**SPRINGS AT WATERVIEW - AMENDED STORM**

GRINNELL DITCH NORTH - PLAN / PROFILE

GRINNELL DITCH SOUTH PROFILE

**STORM B PROFILE**

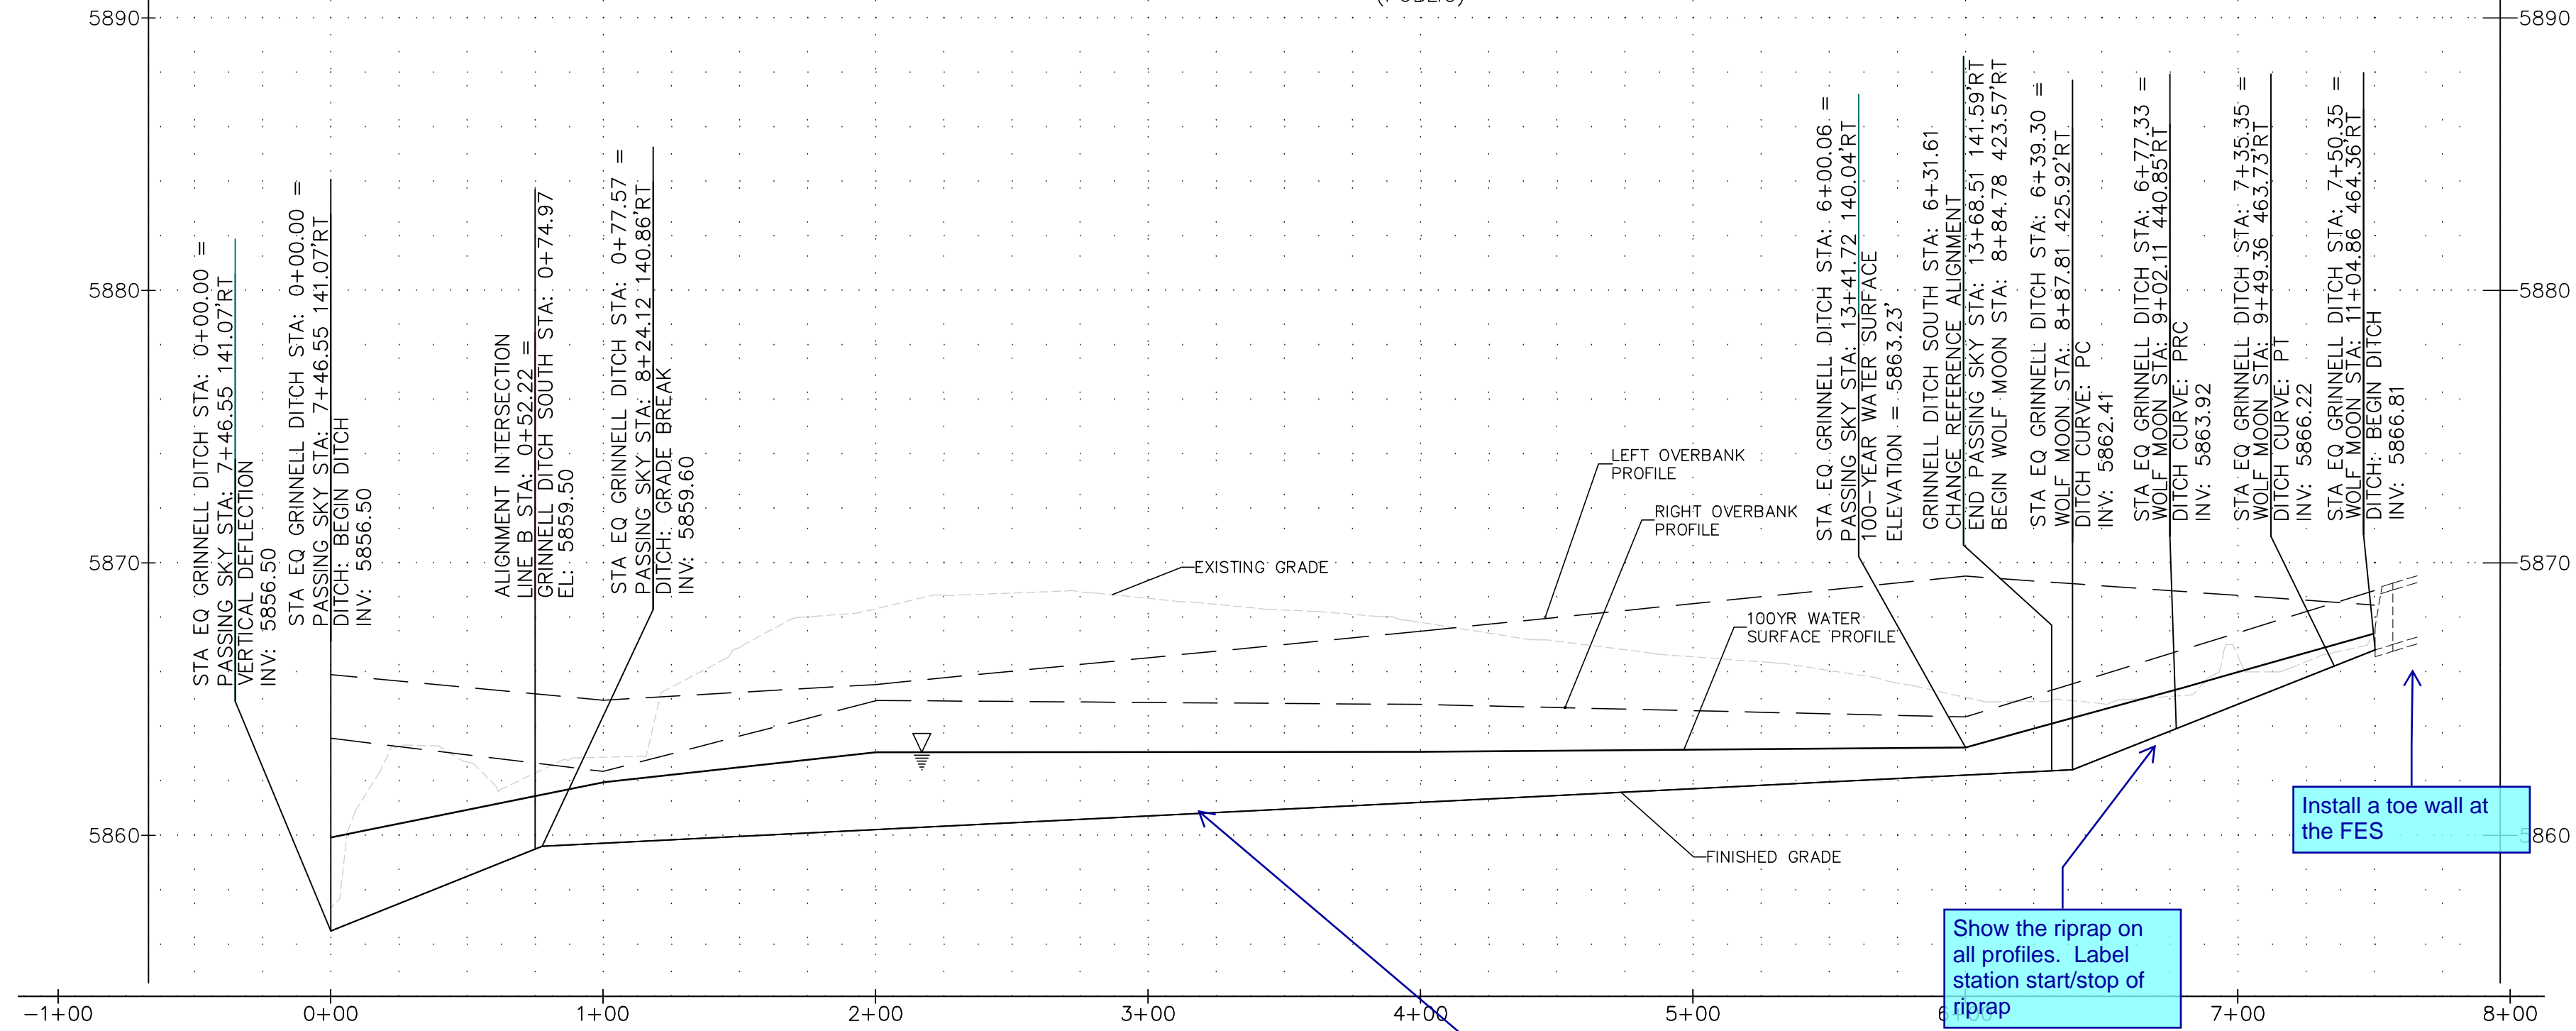
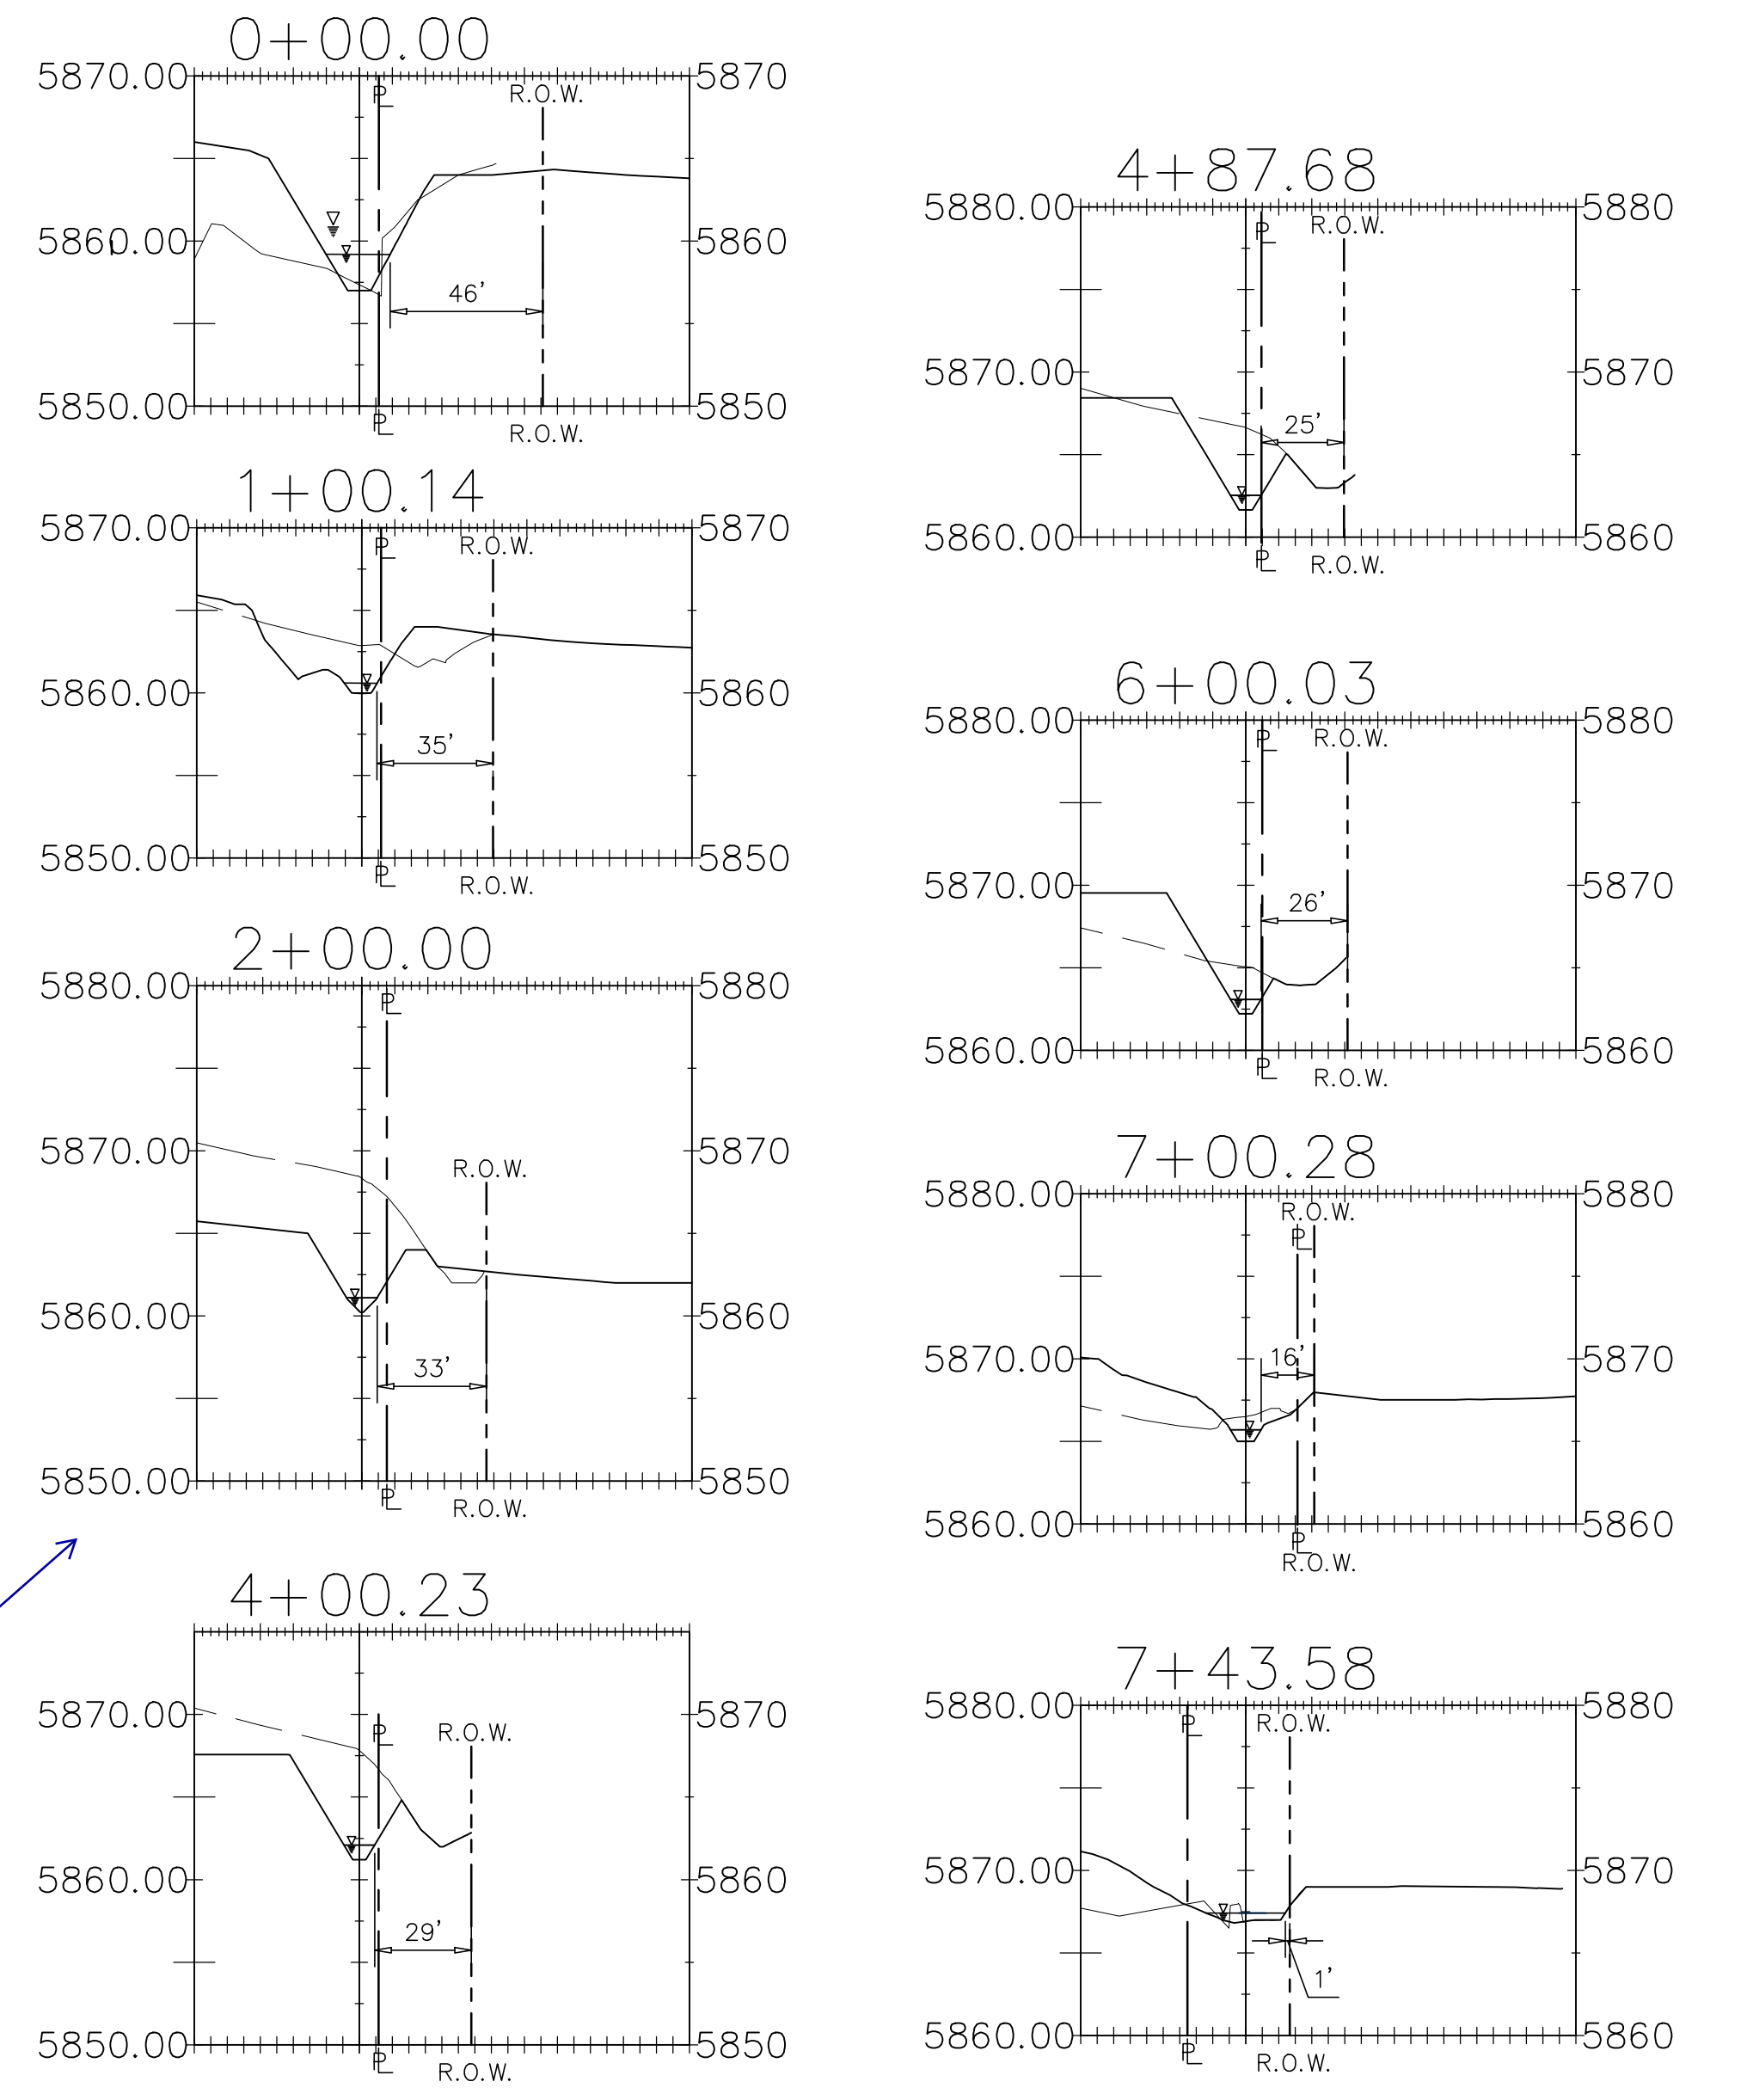
Provide delta angle

Show the riprap on all profiles. Label station start/stop of riprap

Install a toe wall at the FES

plan view indicates this is edge of asphalt, not ROW

label slopes

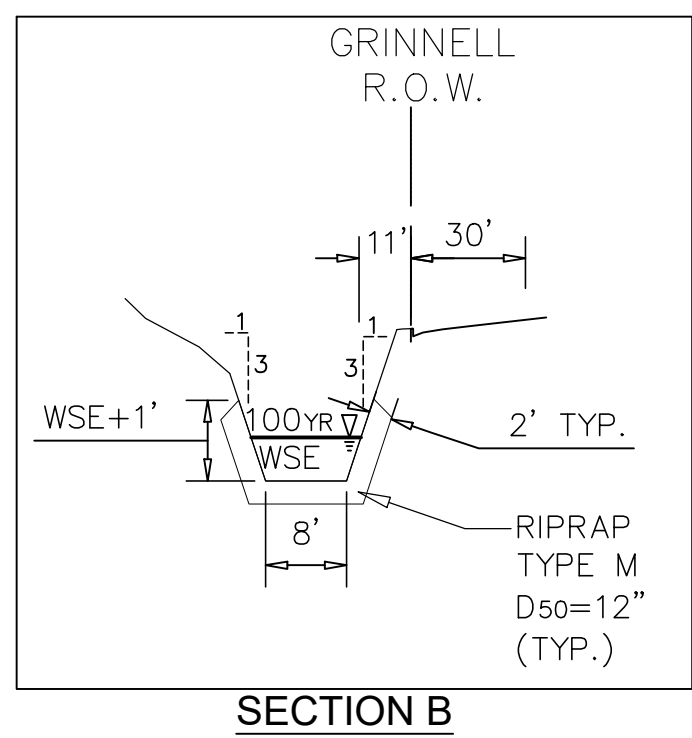
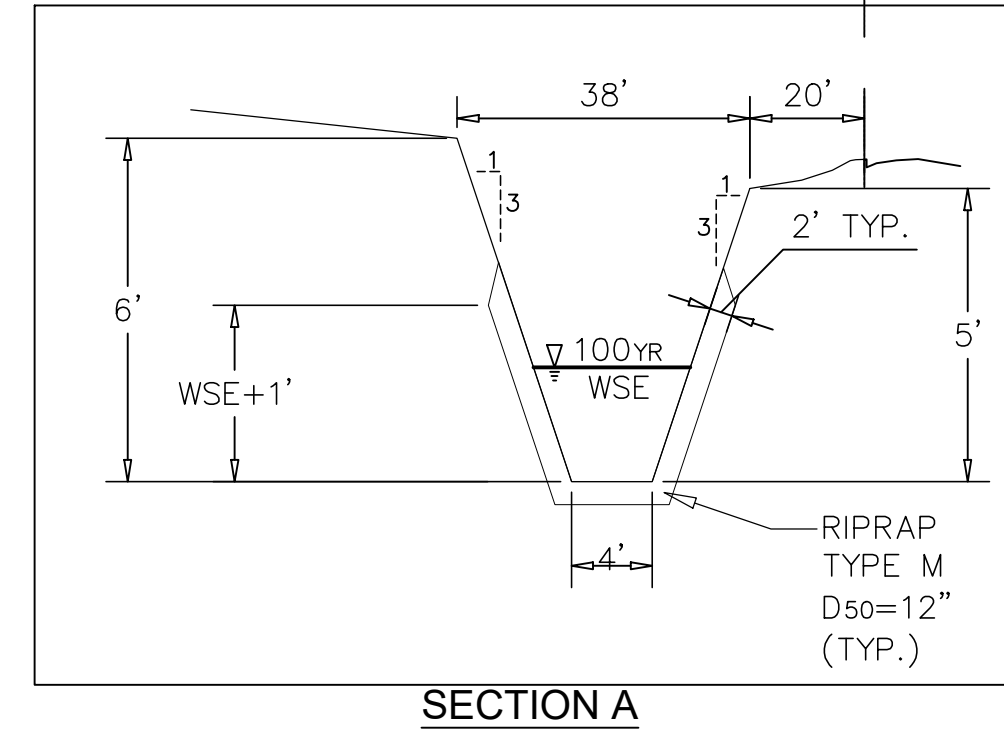
See previous page for comments regarding the cross sections

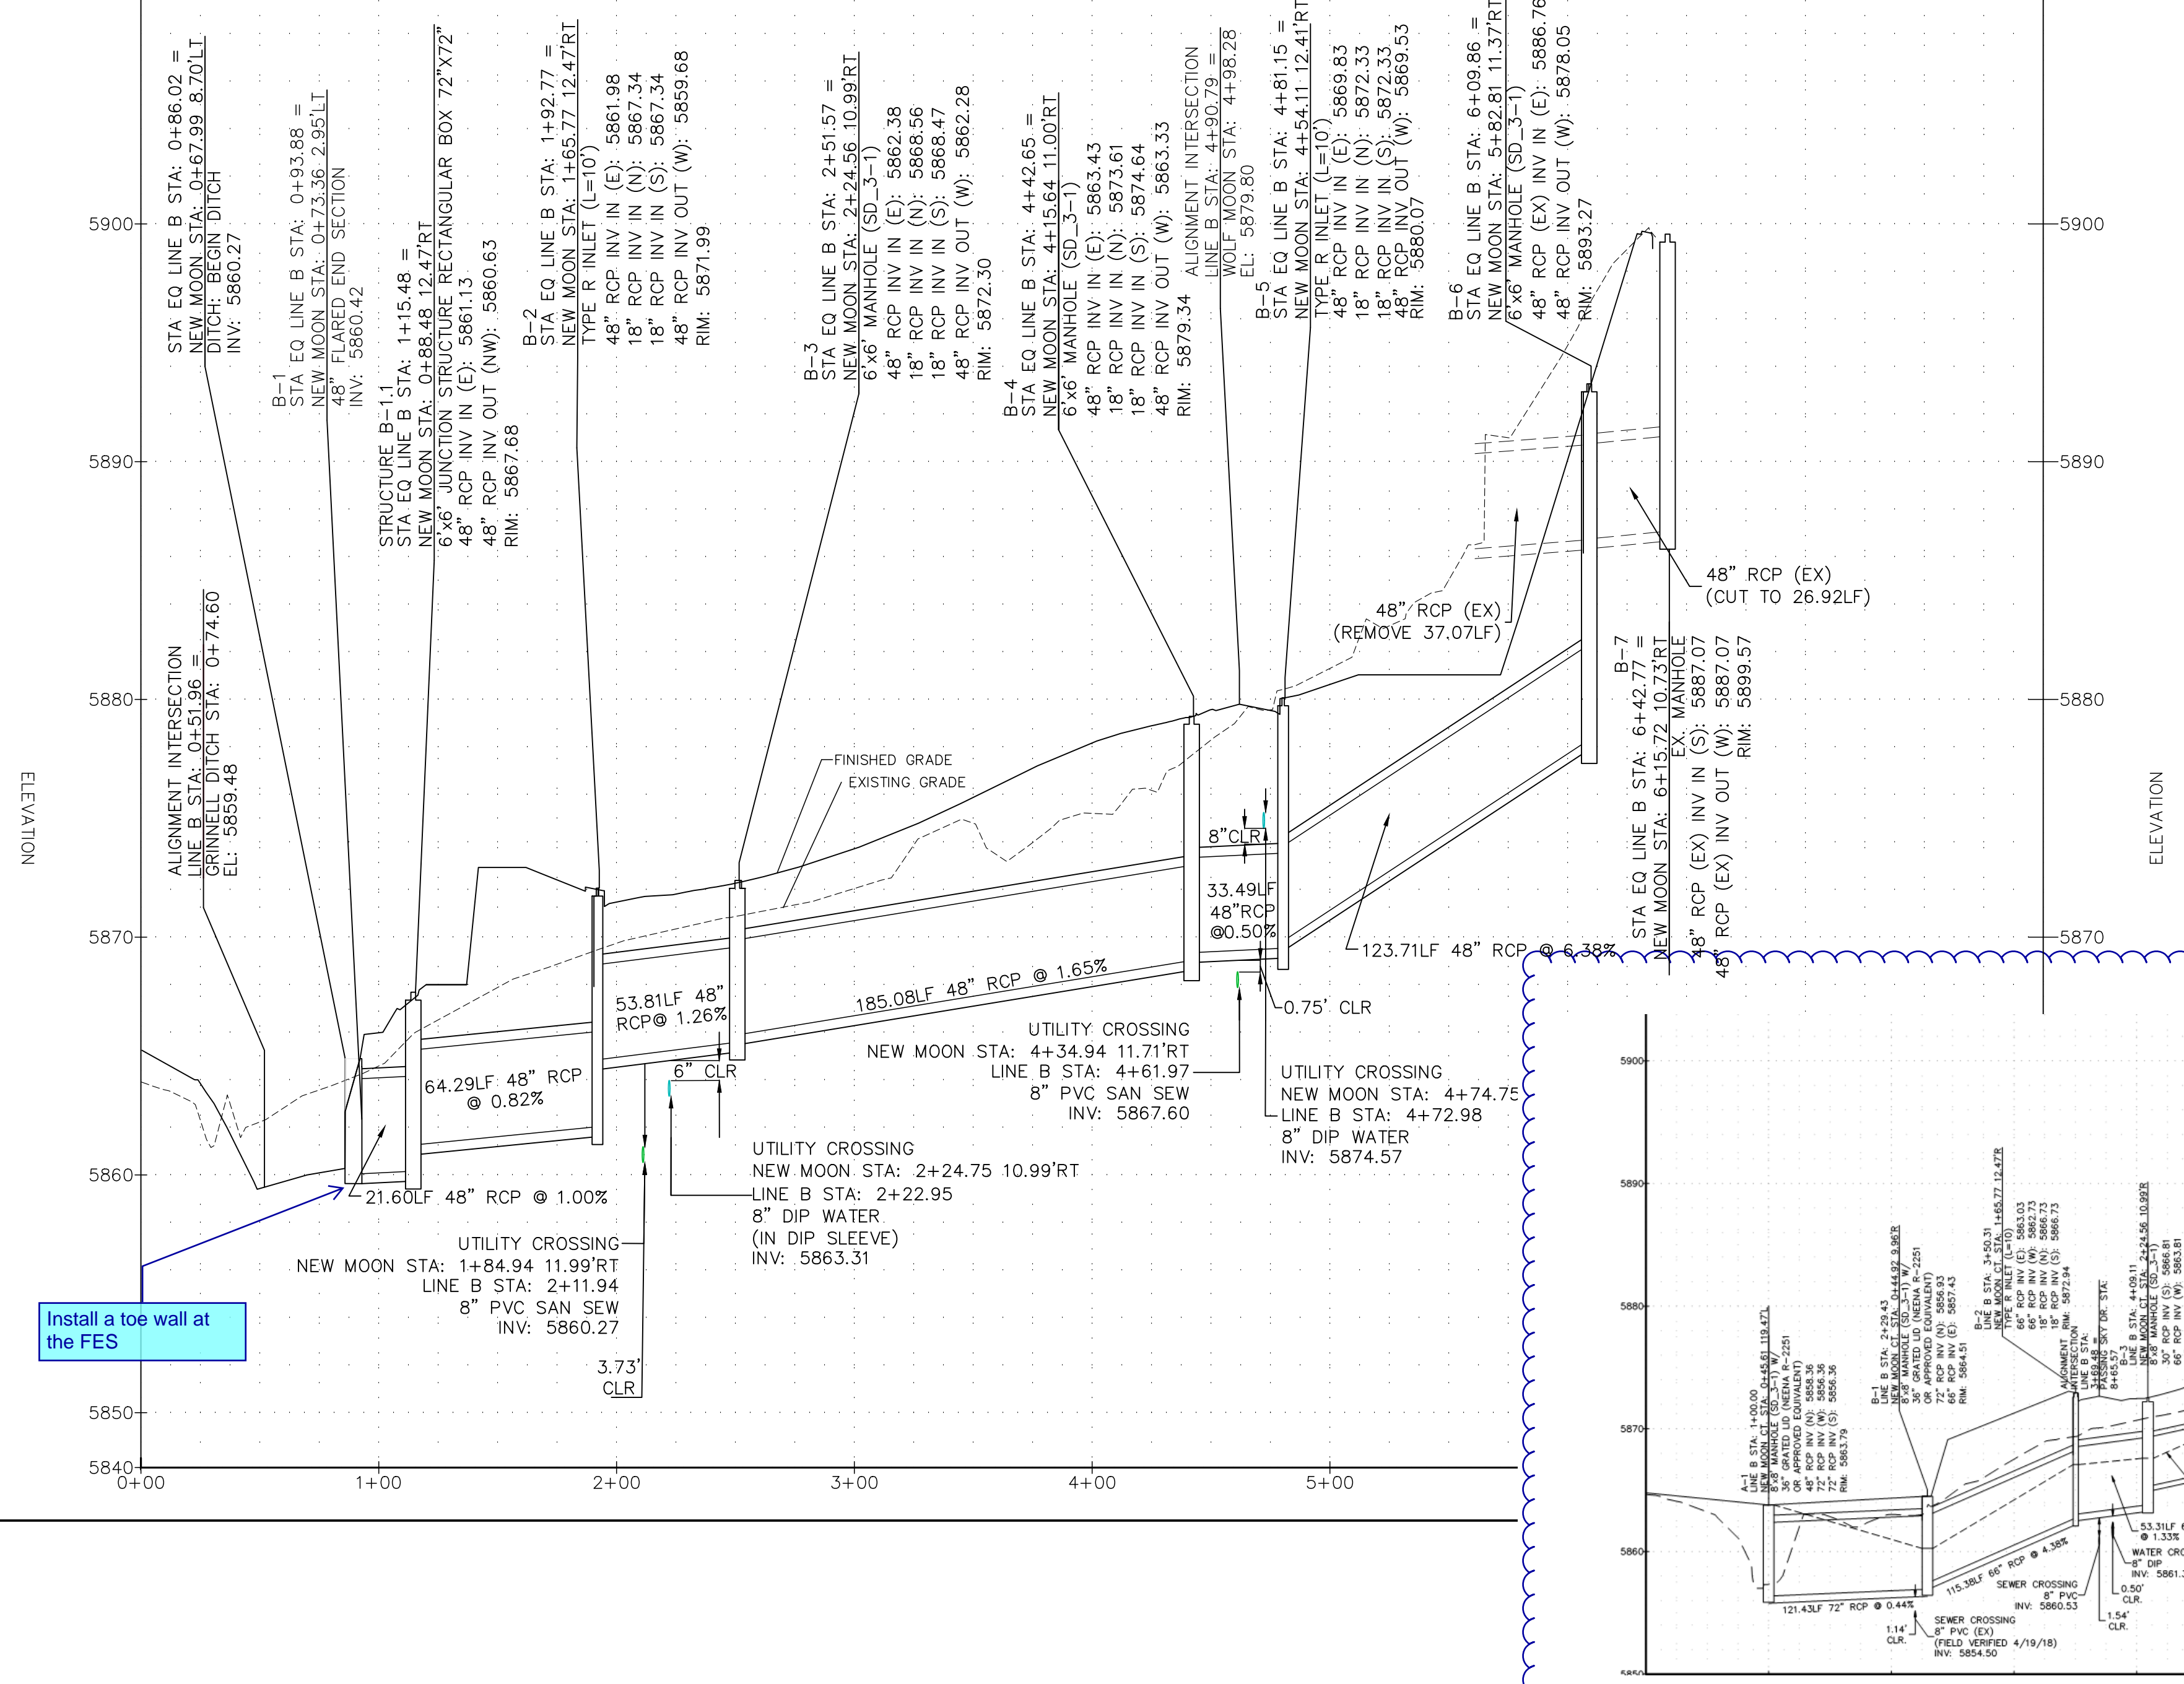
Draw revision cloud around the elements that are revised from the originally approved design.

This entire stormline B is completely altered from the originally approved report. Update the drainage letter to have the supporting narrative and calculations.

Install a toe wall at the FES
